**Grondin Aggregates – Brandy Brook Quarry M 42, L5  
Site Plan Amendment**

**Town of Gorham  
Planning Board Meeting  
December 6, 2021**

**ITEM 5** – Site Plan Amendment: Grondin Aggregates, LLC – Brandy Brook Quarry – a request for site plan review and approval of a winter salt storage shed and stump and brush processing at 57 Ossipee Trail. Zoned Rural (R), Suburban Residential (SR), Urban Residential (UR), Map 42, Lot 5. The applicant is Larry Grondin and he is representing himself.

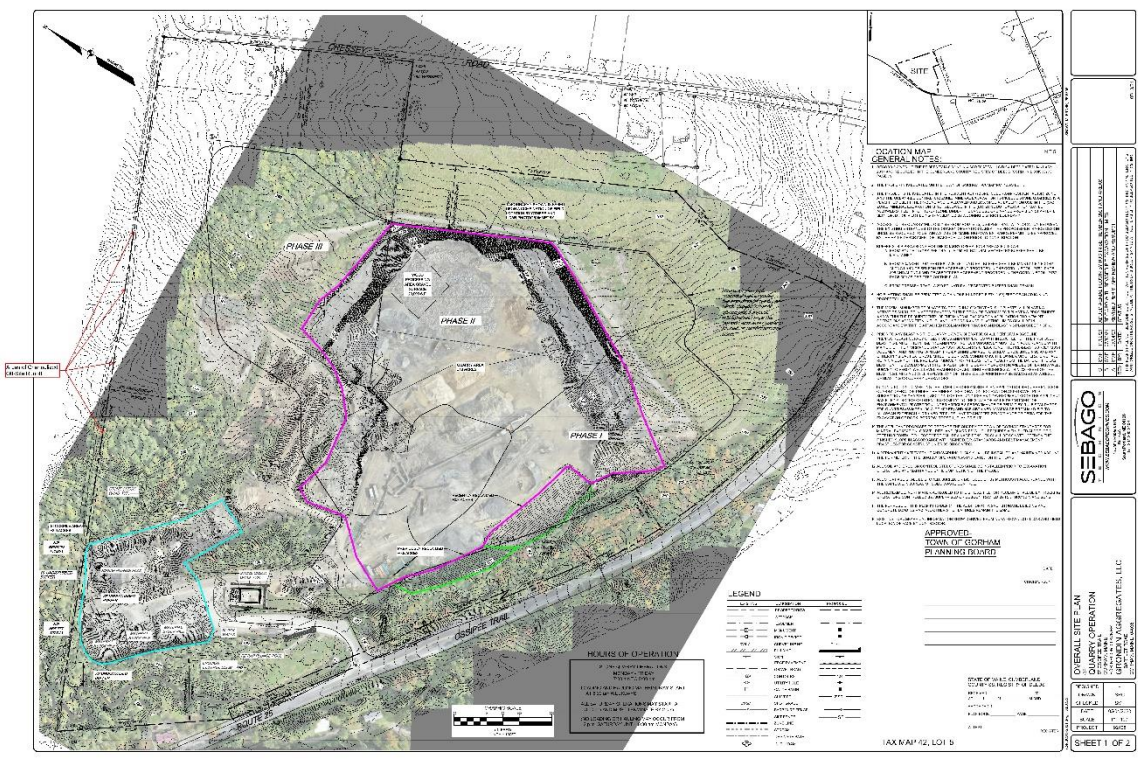
1. Applicant has provided the sources of the land use cover data, soils information, and rainfall data used in the analysis. Rainfall data used in the HydroCAD model was compared to the stated source (Maine DEP Chapter 500, Appendix H) and found that they concur. Methodology for calculating time of concentration was also provided. These satisfy our request for source data. No further comment necessary.

2. The Applicant has revised the hydrologic and hydraulic model to include existing ponding that occurs within the quarry area and drains to analysis point SP-2, which now shows a decrease in peak runoff rate. Previous to this revision, an increase in peak runoff rate was reported.

3. The Applicant has stated that the standard for Gorham has always been based upon peak runoff rates, instead of volume, as development almost always leads to an increase in the volume of runoff. Town to confirm this is accurate.

4. Comments on the stormwater analysis:
  - a. The southern boundary of the post-development drainage area does not follow the southern ridge and cuts through the quarry. The analysis should be revised to include the full post-development drainage area.

- b. The Borrow Pit and Quarry Inspection Report noted a possible unauthorized external drain location to the northwest of the stockpile area. This was noted as a deficiency resulting in off-site impacts to protected natural resources. The report also listed the possible elimination of this discharge as a corrective action item. The report also stated that the DEP requested to review the stormwater plans to determine if the discharge location is licensed. It is unclear if this information has been provided and reviewed. Applicant to provide comment, including identifying the location of the possible external drain location identified in the DEP report.

- c. It appears that stormwater runoff would flow off the northwesterly side of the site. Some channelization is seen in the topography as well. It appears that a large portion of Drainage Area 1S would drain off-site on this northwesterly side of the site instead of draining to Study Point SP-1. Both the pre-development and post-development contours appear to show this drainage pattern. Additional study points should be used in the analysis to provide a more detailed analysis of how off-site runoff is changing as a result of the proposed project. See attached marked up plan showing the areas of concern. The additional study points should include the plunge pools, if they are discharge points.

- d. Clarification should be provided for Pond 2P: Quarry Area. In particular, how the inlet invert elevation of the 18” culvert was determined to be 174’. This elevation appears to be lower than the bottom of ponding of 180’ (lowest elevation of quarry is shown as 180’).
